Access Compliance Report Public Rights-of-Way (Curb Ramps)

Main Street: SKLAR_ST		Cross Street: SNAPDRAGON_ST		Location:	SW
ADA ID: RPAT211101110746	Ramp Type: Type 4 - Parallel	Initial Pass/Fail: Fail	Overall Compliance: No	Severity Score:	16

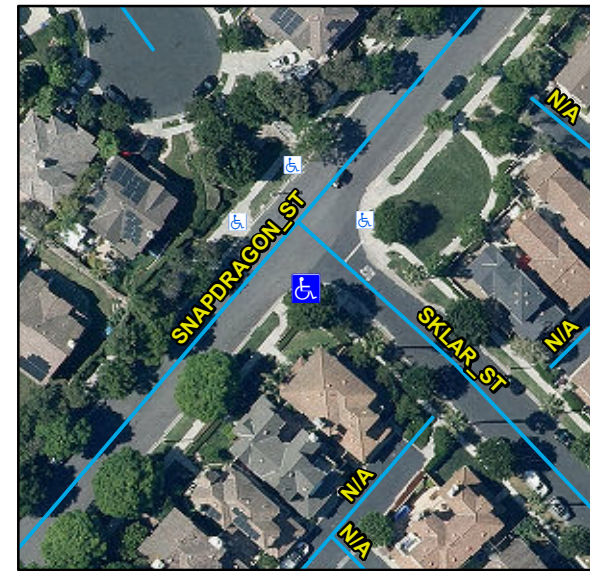
Compliance	Description	Data	Compliance	Description	Data
N/A	Ramp Length LT (in)	96	N/A	Ramp Length RT (in)	95
Yes	Ramp Width LT (in)	88	Yes	Ramp Width RT (in)	88
No	Ramp Run Slope LT (%)	8.8	Yes	Ramp Run Slope RT (%)	7
Yes	Ramp Cross Slope LT (%)	1.1	No	Ramp Cross Slope RT (%)	4.3
N/A	Landing Present	N/A	N/A	DWS Provided	N/A
N/A	Landing Length (in)	N/A	N/A	DWS Contrast	N/A
N/A	Landing Width (in)	N/A	N/A	DWS Length (in)	N/A
N/A	Landing Run Slope (%)	N/A	N/A	DWS Full Width	N/A
N/A	Landing Cross Slope (%)	N/A		DWS Offset Type	N/A
N/A	Landing Movement Obstructed?	N/A	N/A	DWS Offset Left (in)	N/A
	Landing Movement Type	N/A	N/A	DWS Offset Right (in)	N/A
N/A	Landing Shared	N/A			
N/A	Clear Space	Yes			
N/A	Clear Space To Crosswalk (in)	N/A			
N/A	Marked Crosswalk 1	No	N/A	Marked Crosswalk 2	No
	Crossing 1 Direction	NE		Crossing 2 Direction	NW
	Marked Crosswalk 1 Width (in)	N/A		Marked Crosswalk 2 Width (in)	N/A
N/A	Ramp Inside Crosswalk 1	N/A	N/A	Ramp Inside Crosswalk 2	N/A

Remove & Replace Curb Ramp With Two New Directional Ramps or Equivalent.
